Watermead, Henfield Road, Cowfold 13th October 2026

Drainage Technical Note

1.1 This Technical Note (TN) has been prepared to address Horsham District Council (HDC)'s comments on the submitted planning application reference DC/26/0934. HDC comments, reference DC/26/0934, are appended to this TN for ease of reference.

Drawing Number	Rev.
13897_1105	P1

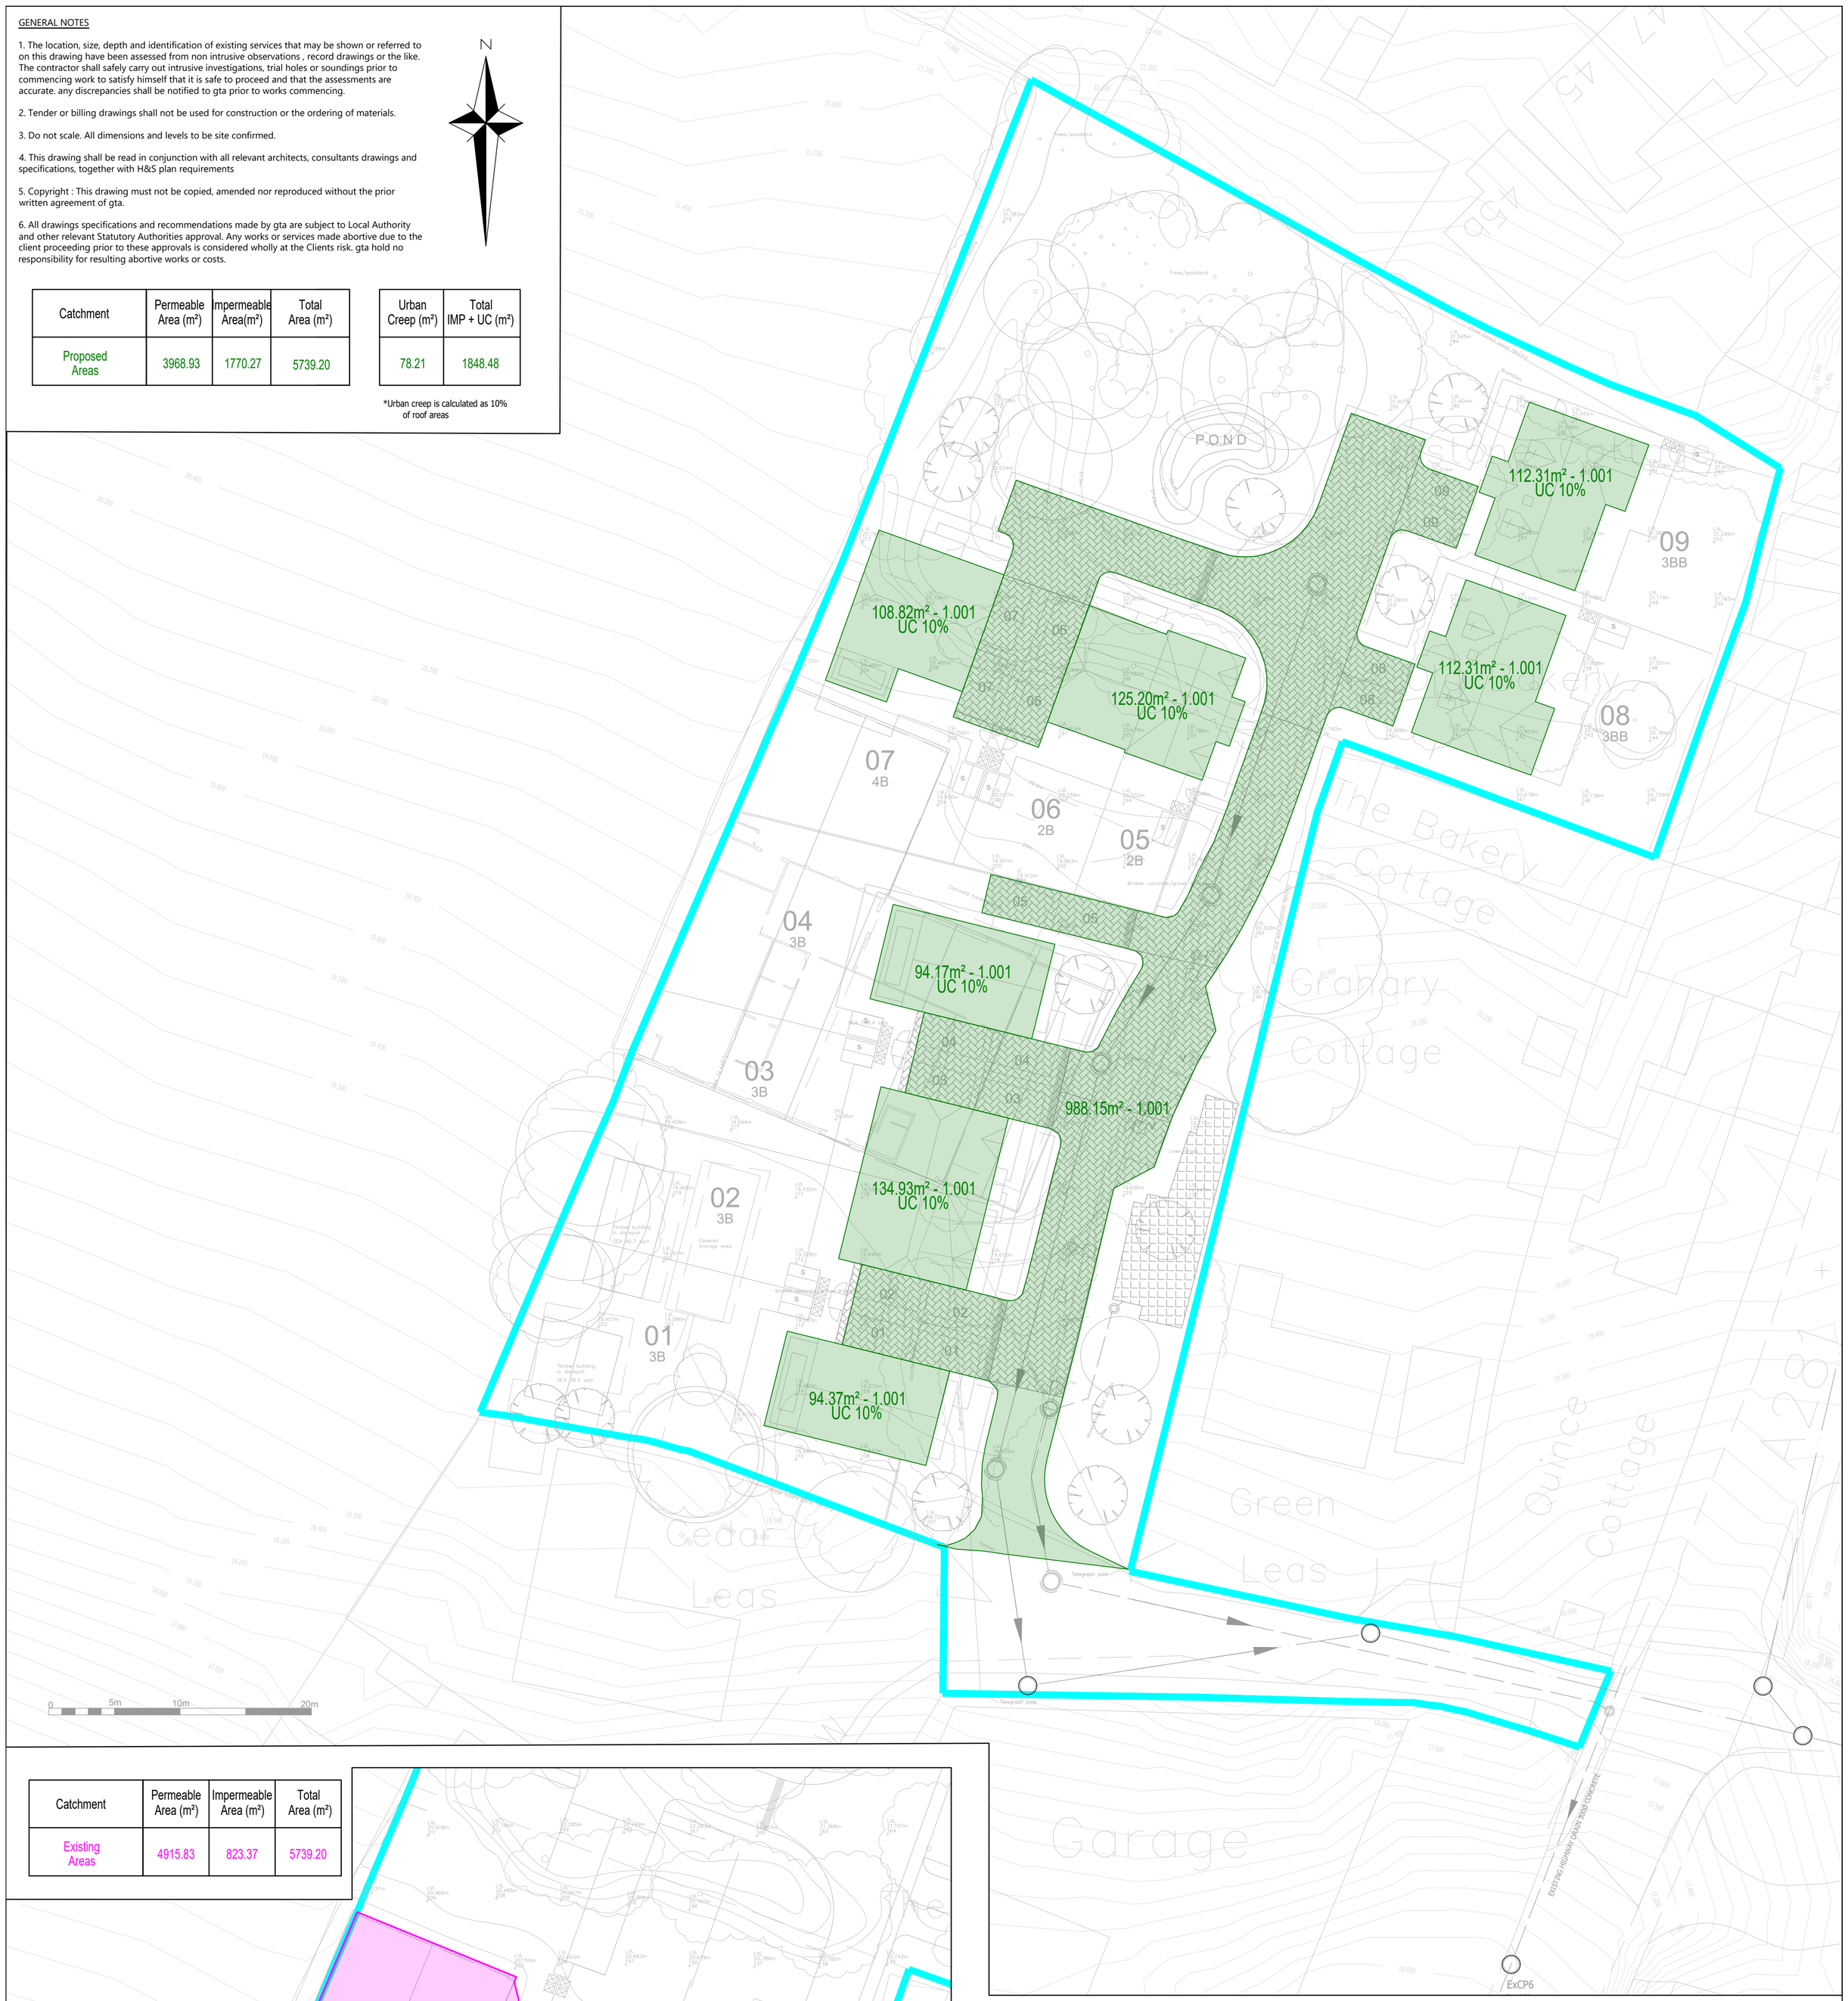
"The applicant should provide a measurement of the total site area, all predevelopment permeable and impermeable areas within the red line boundary, all post-development permeable and impermeable areas within the red line boundary, with supporting catchment plans and calculations".

1.3 A drainage catchment plan reference '13897_1105' has been created to show the total site area and the breakdown of permeable and impermeable areas within the red line boundary for pre- and post-development. This plan is included in Appendix A. This plan reflects the impermeable areas used in the calculations presented within the submitted Flood Risk Assessment (FRA) dated 13/05/2026.

1.7 As demonstrated in the hydraulic modelling calculations included in Appendix G of the FRA dated 13/05/2026, and referring to the catchment plan reference 13897_1105 (see Appendix A), it has been demonstrated sufficient attenuation has been provided for all proposed impermeable areas, with 10% urban creep added to all roof areas.
